REQUEST

Current Zoning: MUDD-O (mixed use development, optional)
Proposed Zoning: MUDD-O SPA (mixed use development, optional, site plan amendment)

SUMMARY OF PETITION

The petition proposes an amendment to the previously approved rezoning petition to allow the reuse of an existing building and additional redevelopment on the site. The proposal would modify the conditions related to signage and additions to the existing building that remains.

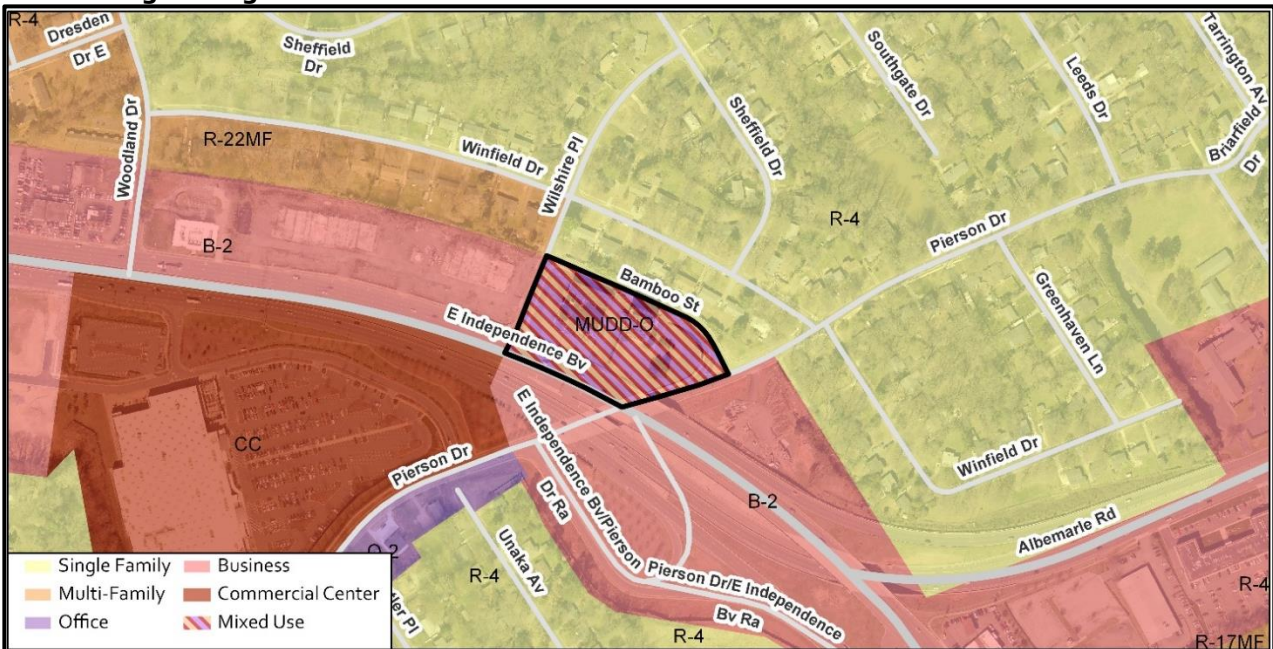
3. ~~Add a conditional note to specifying replacement of the existing CATS bus stop pad as indicated by the site plan.~~ Addressed
4. ~~Revise the site plan (RZ-2) to show the existing stairs that are shown in the sidewalk area along Bamboo Street to be removed from the right-of way. In addition, please propose to install a safety rail or a gated system to prevent pedestrians, within in the right-of way, from falling into the drop-off.~~ Addressed

5. ~~Revise the site plan (Sht. RZ-2) to clarify whether the existing driveways on Bamboo Street will remain or be replaced. Sheet RZ-2 calls for the existing driveways to remain, but the site plan shows the existing Commercial Type II Driveway to be replaced with a Type II Modified Driveway at the access west of the existing Ervin building.~~ Addressed

6. ~~Revise the site plan (RZ-2) to include proposed and existing sidewalk labels and dimensions.~~ Addressed
